工程指示 / 要求簡箋(E.I.)

工程指示編號：EI / 3187 / 21 修改版次：-
 工程編號：J - 852 工程名稱：亞皆老街中電
 工程項目：佛沙窗 師父板 (4th)
 收件人：生統 / 王良 發件人：Ant Yeung 日期：22/03/2021

To : Gammon Engineering & Construction Co., Ltd Ref no : 1980045.1-SM-50003-00
Attn : Mr. Dick Yuen / Mr. Jackson Mok Date : 9 September 2020
From : Ms. Cosimo Wong / Mr. Neo Wong Required Reply Date: 14 days
Project : Proposed Residential Development at 139 – 147 Argyle Street, Kowloon
Subject : Façade Works – Site Inspection Report #6

Site Inspection Report # 06

Photo #45

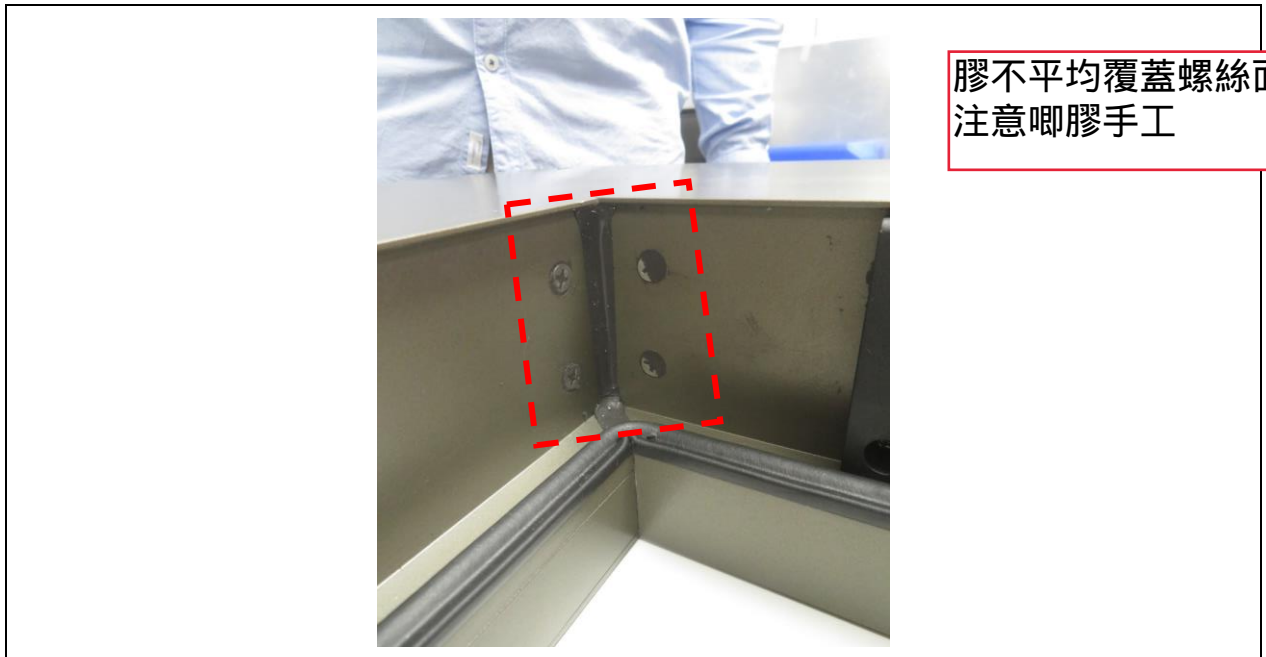
膠不平均覆蓋螺絲面
 注意啱膠手工

Observation (Window Frame)	Inconsistent sealant application on fixing screws (i.e. screw heads with/without sealant) at the corner of window frame.
Recommendation	Ditto.

欠膠覆蓋螺絲面
 注意啱膠手工

Observation (Window Frame)	Screw heads without sealant application.
Recommendation	Rectification is required. Sealant application on fixing screw should be standardized.

Photo #49

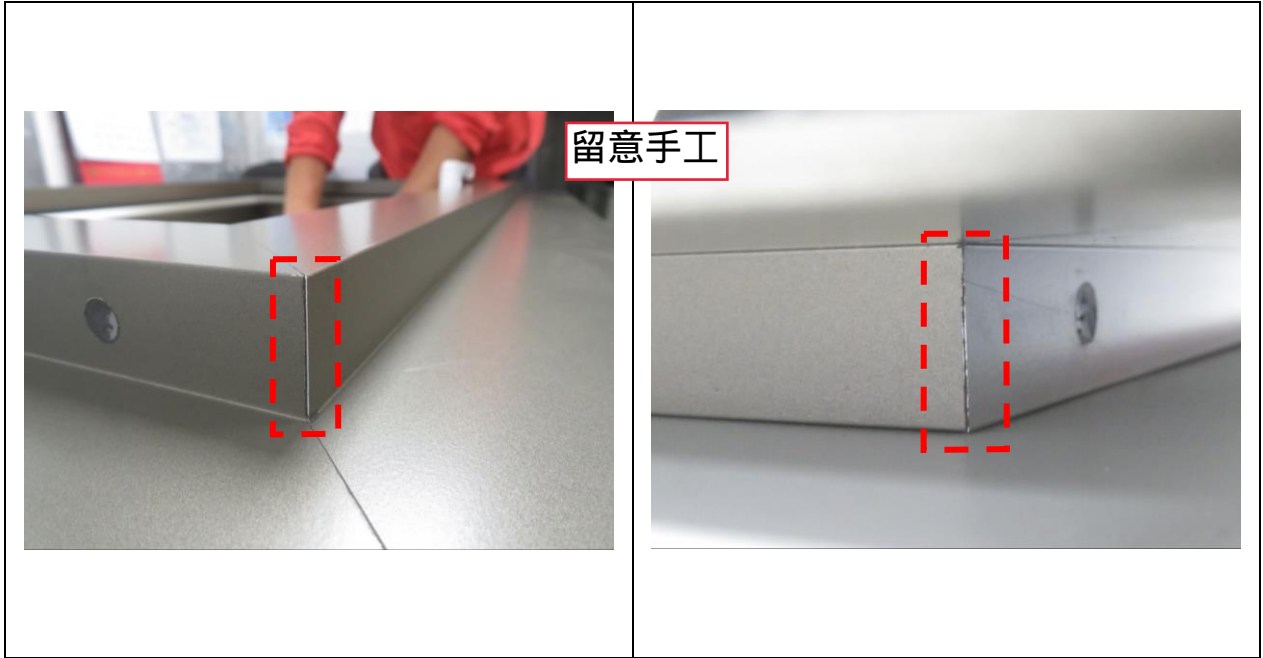
Mitre joints with poor workmanship.

Improvement in quality of fabrication as well as assembly is recommended.

Photo #50

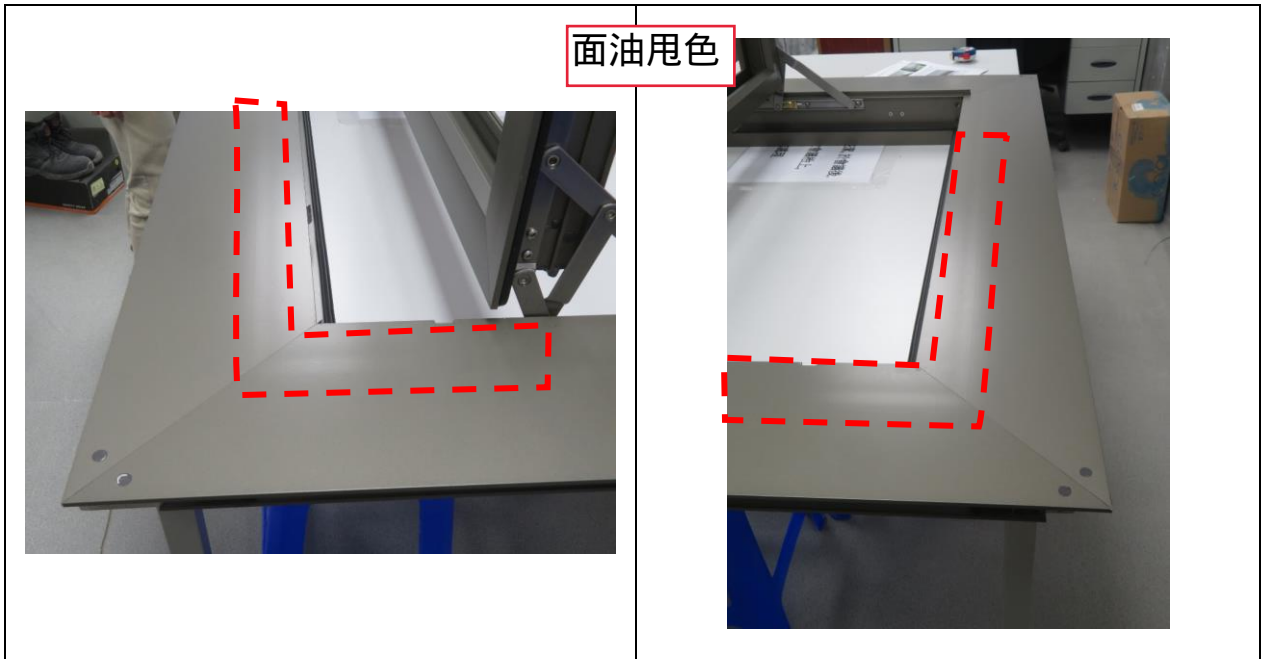
Streaks on coated surface was observed.

Improvement in quality of coating is recommended.
